**BASALT WASTE ISOLATION PROJECT REVIEW
BY PACIFIC NORTHWEST LABORATORY'S REVIEW TEAM**

Letter Report

November 1983

**Pacific Northwest Laboratory
Richland, Washington 99352**

FIGURE 2.1. Small-Scale Structural and Stratigraphic Discontinuities in the Umtanum, Flow at the Emerson Nipple Section. (Source: SCR Figure 3-29, page 2.5-30).

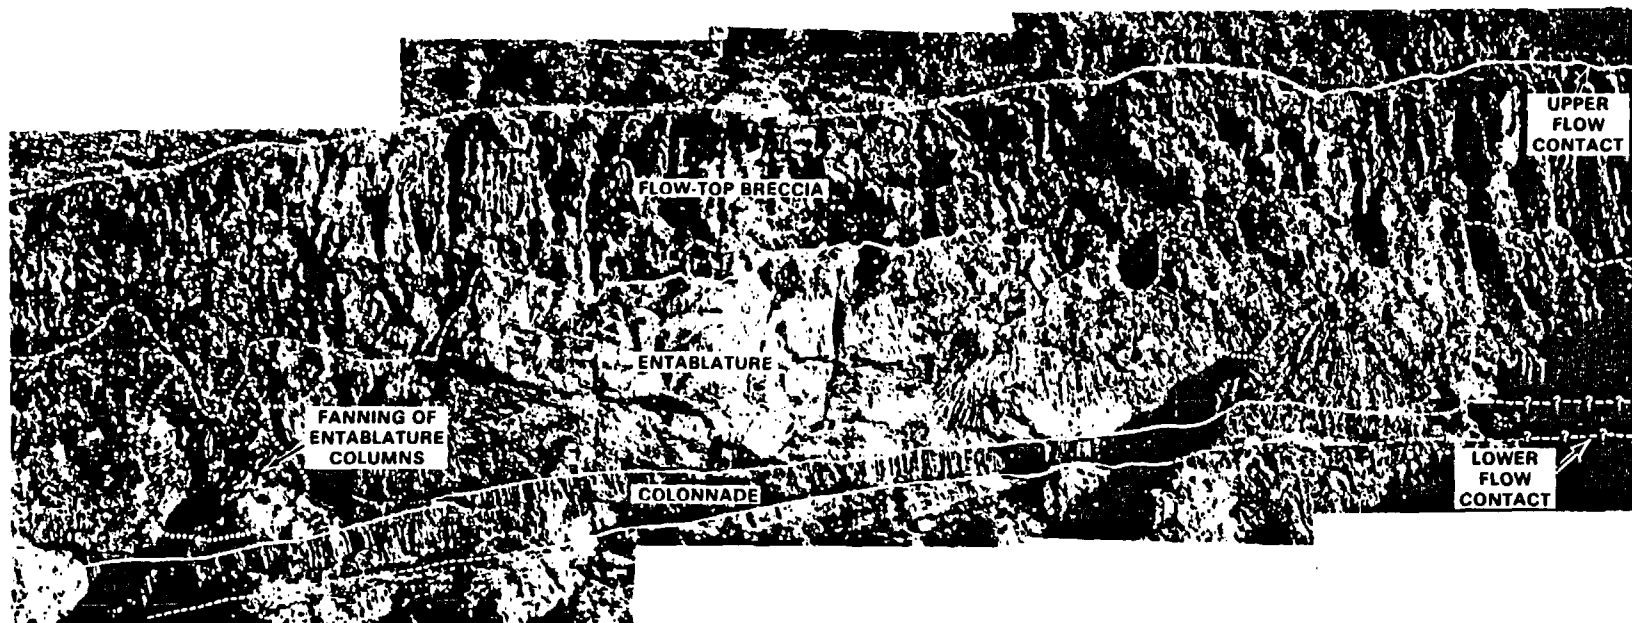
One unresolved technical question is the thickness and lateral extent of the candidate basalt flows. This particular question has gained significant attention since drilling RRL2. The brecciated flow-top for the Umtanum was found to be 148 ft, which nominally represents 64% of the total flow thickness of 197 to 231 ft. The conclusion was that localized thickening or thinning in the flow-top and related fanning joints occur in the reference repository location. Several stratigraphic features that may be encountered during the construction of the miles of tunnels for a repository include: "(1) locally thickened flow-top breccia (i.e., the partially welded broken rock formed in the upper part of a flow by explosion or flowage of a partly congealed basalt flow), (2) zones of potentially high vertical permeability formed by emplacement and cooling of the lava flows (e.g., margins of individual flows, zones formed by interaction of hot basalt and water, and joints formed by cooling but not sealed by secondary mineralization), and (3) faults, particularly the strike-slip variety and shear zones" (USGS, 7/28/83). Although Figure 3-29 of the SCR (1982) is likely an extreme example, it is reproduced here to lend perspective on this intraflow stratigraphy question (Figure 2.1). Examples of intraflow structural and stratigraphic discontinuities in the flow are depicted in this photograph of the Emerson Nipple outcrop.

It is difficult to predict the probability of encountering one or more of these potentially pressurized (1500 psi), water-bearing zones at depth; and the regional paleogeology would support the assertion that the probabilities may vary significantly from flow to flow. Based upon a limited analysis of basalt outcrops, the USGS staff suggest that the chance of encountering such intraflow anomalies might be on the order of 5 to 25% for the Umtanum flow and somewhat less for the Cohasset (USGS, 7/28/83). Regardless of the range of

estimates, it seems clear that there is a reasonable possibility of encountering intraflow discontinuities during repository construction. Detailed contingency plans should be established to deal with the possibility of mining into a high pressure, high permeability water-bearing zone (see Section 2.3 on BWIP plans).

FIGURE 2.2. S-W/N-E Stratigraphic Cross-section as Inferred from Initial Interpretation of Magnetotelluric Survey Data (after Halpin, 1982)

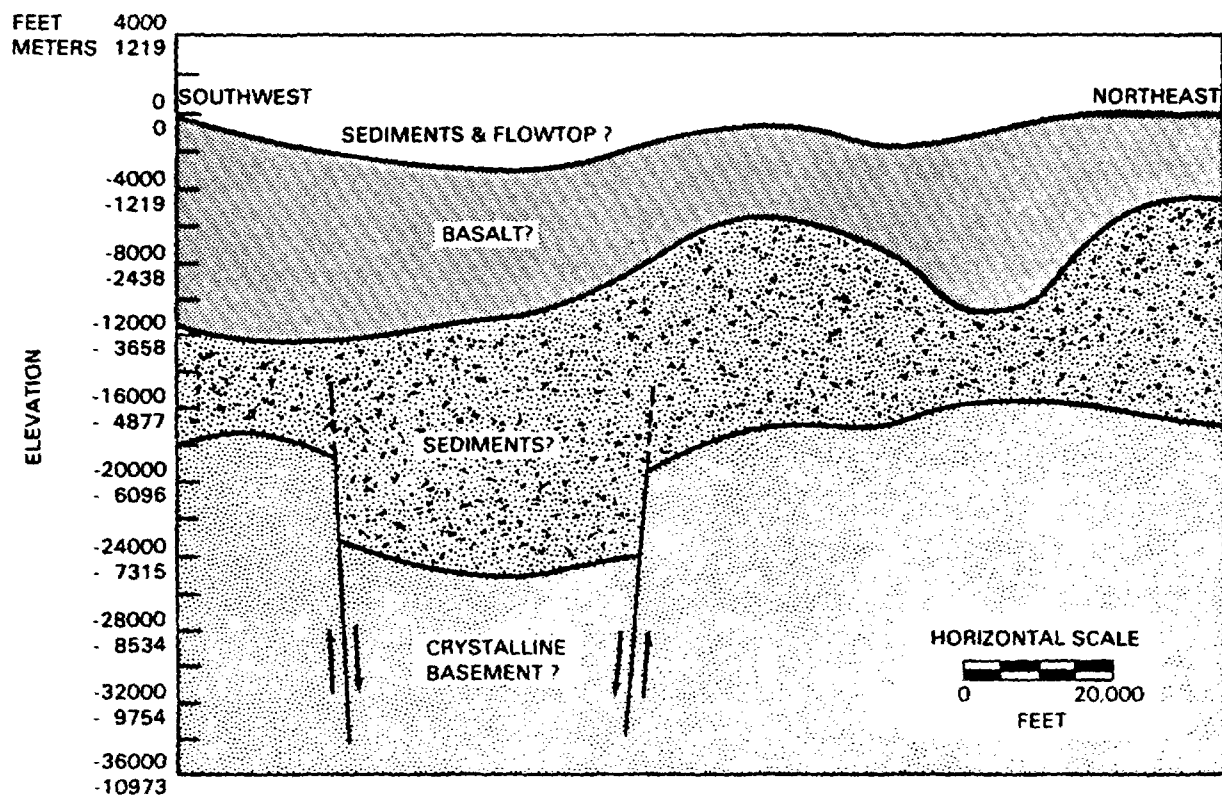
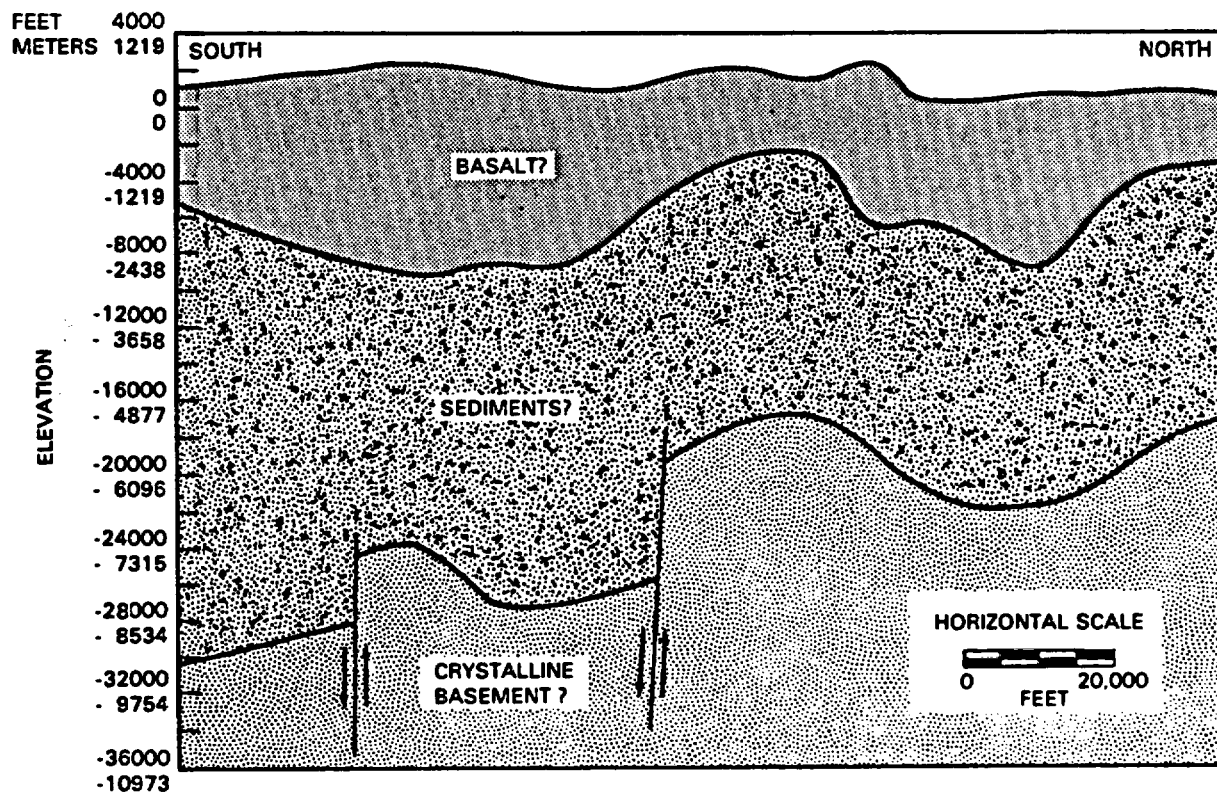
The reader is cautioned not to derive premature conclusions from these interpreted crosssections. For example, the block faulting depicted in the figures is a subject of considerable controversy and may or may not actually exist. Consequently, no locations are provided in the figures, though the crosssections are essentially contained on the Hanford site. The various layers depicted in the crosssections generally refer to: (1) the relatively conductive sediments plus the upper brecciated basalt flowtop overlying the uppermost basalt layer; (2) the relatively resistive sequence of basalts; (3) the relatively conductive layer below the basalts, inferred to be sedimentary material; and (4) the lowest resistive layer, generally inferred to be a crystalline basement rock.

There are tremendous difficulties and uncertainties associated with characterizing the deep stratigraphy and structure as depicted in the figures and subsequently correlating this with surface or near-surface features. The primary methods for characterization are: 1) geophysical analyses (e.g., magnetotelluric, gravity, magnetic, seismic reflection, and seismic refraction) and 2) geological extrapolations from available outcrops. For example, the magnetotelluric data shown in the figures may have a resolution of 10 to 20% (Price, 9/18/83). However, this assumption has not and apparently cannot be

validated for basalt at this time because geophysical techniques have not been calibrated or tested for sensitivity at a basalt site. Furthermore, the magnetotelluric interpretation presented in the figures was based upon the assumption of lateral continuity of the electric resistance of the inferred sediments below the basalt. An alternative assumption is to fix the continuous lateral resistivity of the basalts and allow the value of the sediments to float in a constrained manner. This alternative interpretation (which was in draft format and not available for this report) appears to reduce significantly the vertical relief at the base of the basalt sequence (basalt/sediment interface), typically smoothing across extremely thick or thin areas of the basalt. More dramatic structure is thus transferred to the interface between the sediment/crystalline basement.

FIGURE 2.4. Working Draft Geophysical Feature Map (ST-14)

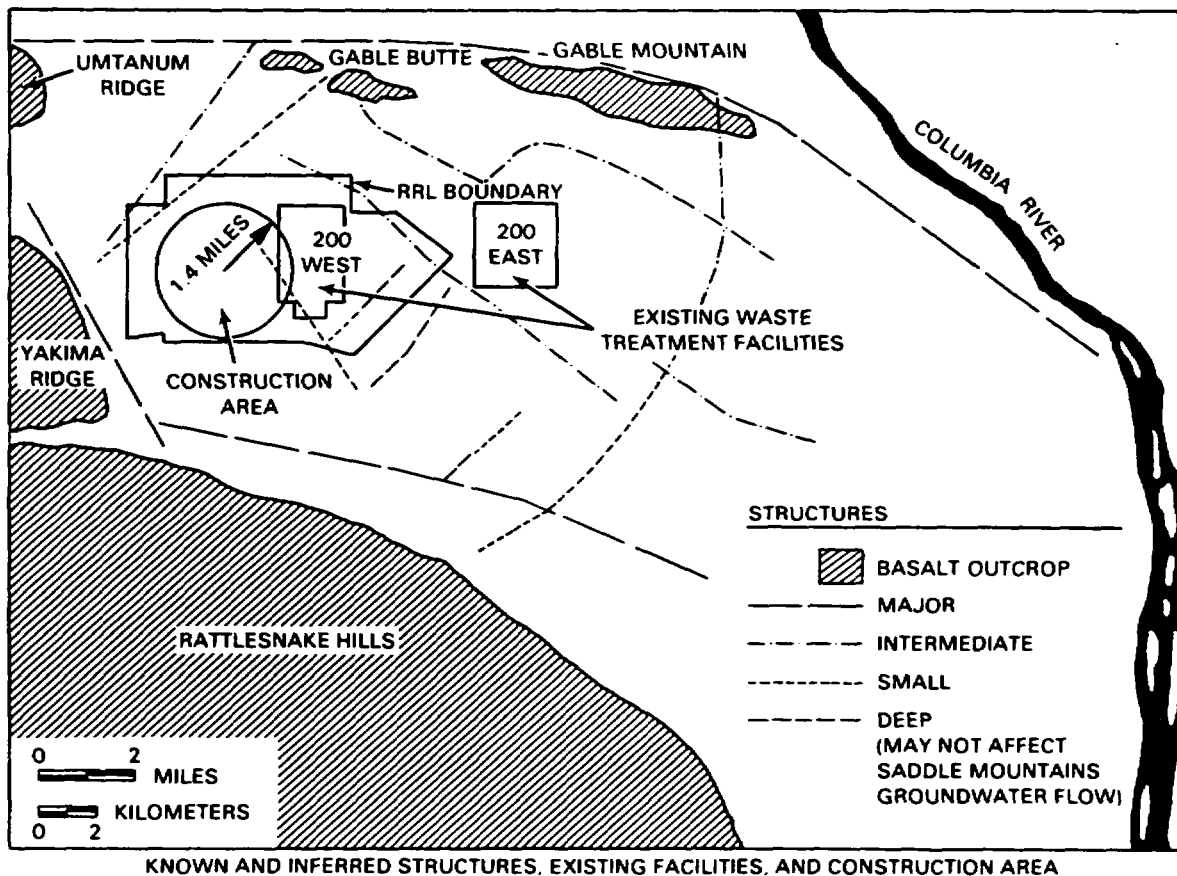
"The Yakima Barricade Area contains both the Nancy linear and the Hydrologic Barrier anomaly. This area is important because of the anomalous hydrologic heads that have been observed and because many of the aeromagnetic anomalies trend into the RRL."

"The northern extension of the RAW past Snively Basin, the Hanson Creek anomaly and the Hog Ranch/N-S gravity gradient are all features that remain unresolved and warrant investigation. Of particular importance is the potential for structures splaying off the aforementioned features into the RRL."

"The eastward extension of Yakima Ridge has been traced by gravity, aeromagnetics, and ground magnetics. Several crosscutting anomalies have been detected (primarily NW trending). Two N-W trending, aeromagnetic features are also located within the RRL. These anomalies, D-218 and N512, have weak aeromagnetic signatures, but because N-512 is also detected via bouguer gravity and both features are located near the proposed site for the exploratory shaft, their identity should be resolved."

FIGURE 6.1. Approximate Relationship Between Excavation Stability, Rock Mass Quality, or Rock Mass Rating and Maximum Compressive Boundary Stress (after Hoek, 1981)

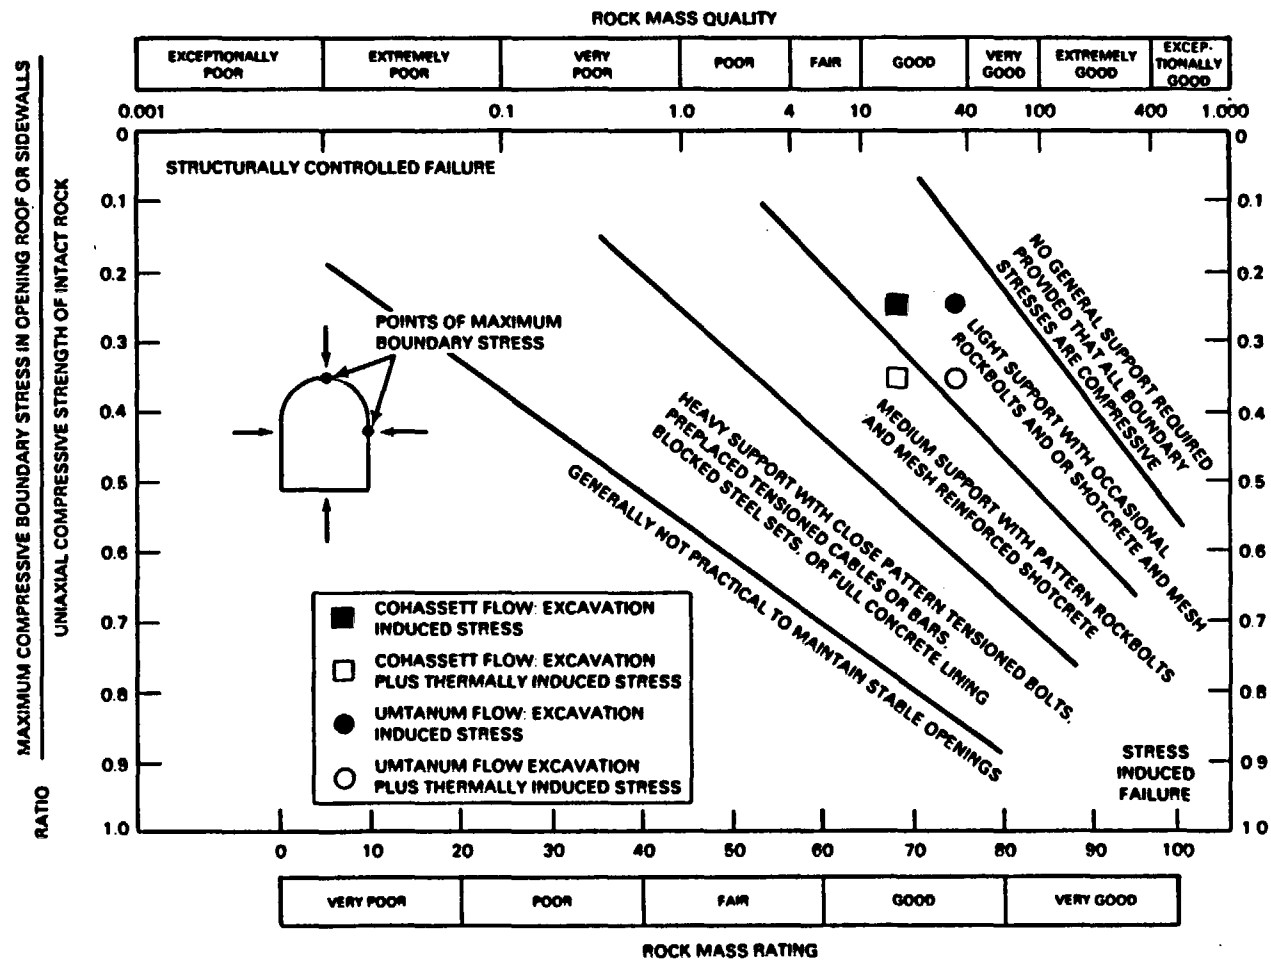
In the analysis, RHO estimated the maximum compressive boundary stress by assuming a horizontal to vertical stress ratio of 2:1 and a stress concentration factor for an elliptical opening. The uniaxial strength was estimated to be 364 MPa, based on the intact strength of Umtanum basalt. The intersection of the parameters is illustrated in Figure 6.1. The conclusions of the analysis were:

PNL has expressed concern that the various rock mass rating parameters had not been adjusted for the specific conditions present in the Hanford basalt. In addition, the intact strength values used did not consider all of the candidate basalts and the uncertainty of the data. PNL provided other support estimates using existing data and the Hoek diagram. The data represented the worst rock strength values and lowest rock mass rating values and resulted in a considerably higher support requirements. The intention of PNL was to demonstrate the range of conditions and attendant conclusions that could be encountered and to encourage a more thorough treatment of the data.

Laubscher and Taylor (1976) and Kendorski et al. (1982) have developed methodologies for adjusting the rock mass rating for various conditions. The conditions include: Number of tunnels (tunnel interactions), Excavation method

(blast damage), depth of the excavation, in situ stress, extraction ratio, degree of weathering, and width, location and attitude of major structural discontinuities.

The effect of these adjustments is a lowering of the rock mass rating and a more conservative estimate of the rock support requirements. No evidence has been found that any of the adjustments of the rating system parameters were made by RHO . However, in a later draft of the RHO-BWI-ST-28P-Draft, October 1983) the treatment of the intact strength data was considerably improved by taking a statistical approach to the data. These changes resulted in a more conservative support estimate with a majority of the Cohasset support requirements falling into the "medium support" region when the thermal stresses were added to the excavation induced stress.

Figure 6.2. Strength and Modulus as Function of Temperature (Schmidt, 1981)

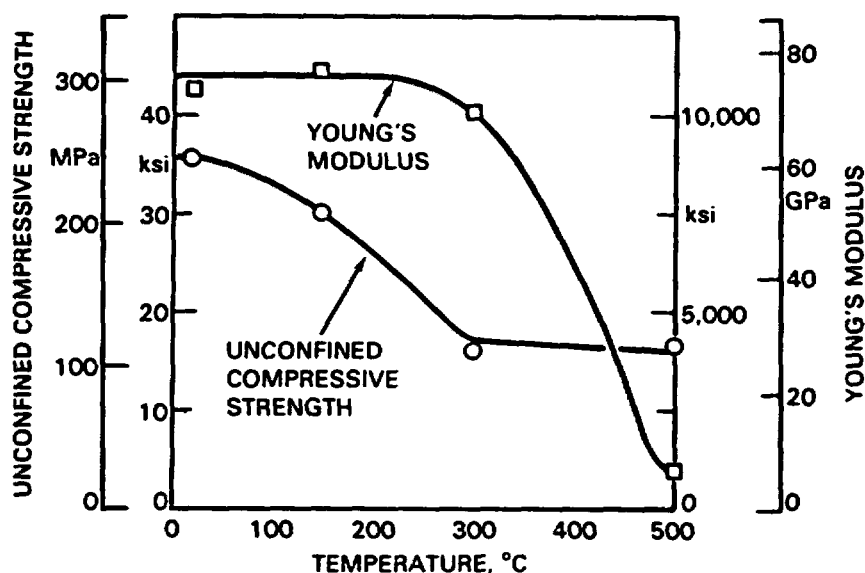
There is some evidence that the strength of basalt may decrease with increasing temperature. Parsons Brinckerhoff has reported a decrease in rock strength with increasing temperature and proposed the relationship in Figure 6.2. (Schmidt, 1980, 1981) the chart is based on laboratory strength tests at elevated temperatures performed by the Colorado School of Mines (CSM, 1979,

a,b). Foundation Sciences, Inc. (FSI) reported as much as a 50% decrease in intact basalt strength with increasing temperatures (300°C) (RHO-BWI-C-100, 1981). RHO decided to disregard the results due to quality assurance questions regarding the basalt samples used. However, both results indicate a lowering of basalt strength at high temperatures. Referring to Hoek's chart, a lower value of strength results in a greater stress to strength ratio and an increase in the recommended support requirements. Further investigations are necessary to establish the effect elevated temperatures have on the strength of basalt.

FIGURE 6.3. Approximate Relationship Between Excavation Stability, Rock Mass Quality or Rock Mass-Rating and Maximum Compressive Boundary Stress (after Hoek, 1981)

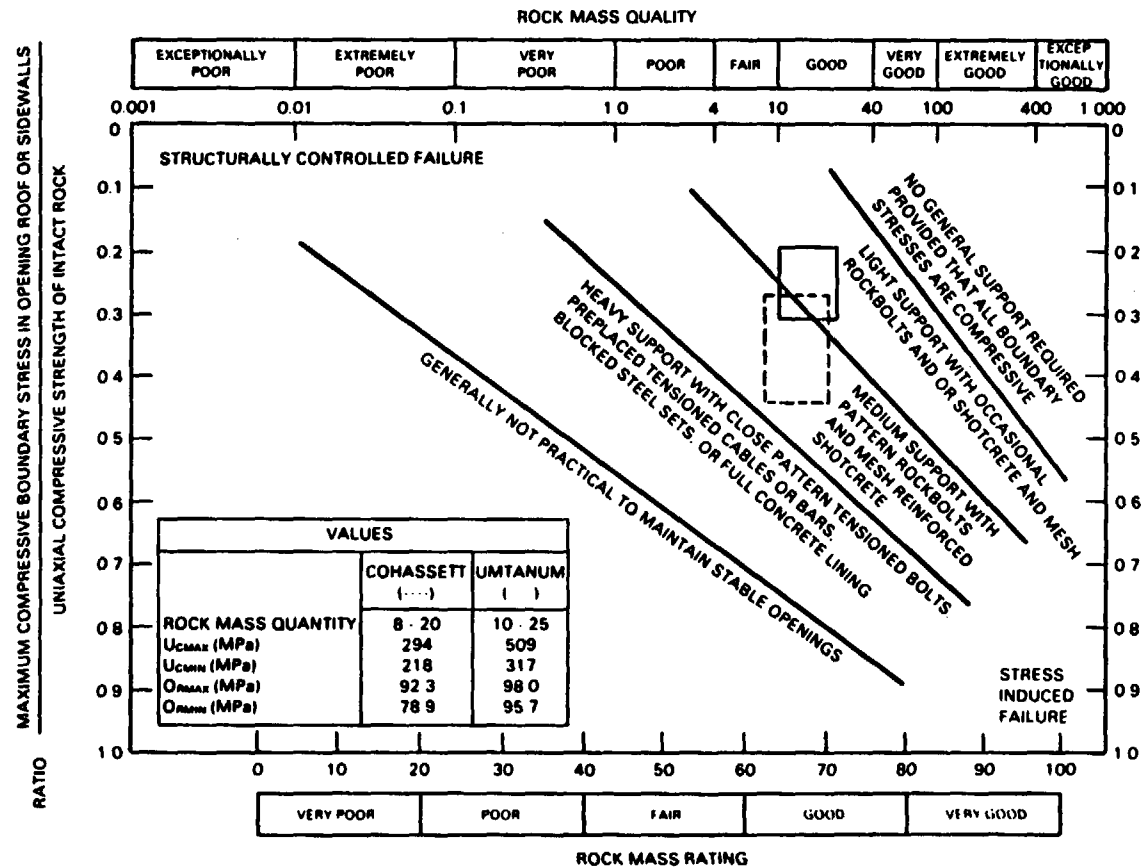
The intersection of the parameters on Hoek's chart is illustrated in Figure 6.3. The revised support estimates are:

(Umtanum) "mostly 'light support with occasional rockbolts and/or shotcrete and mesh'. However, heavier support would be required if flow-top breccia were encountered.....These areas with apparently weaker joints could require 'medium support'."
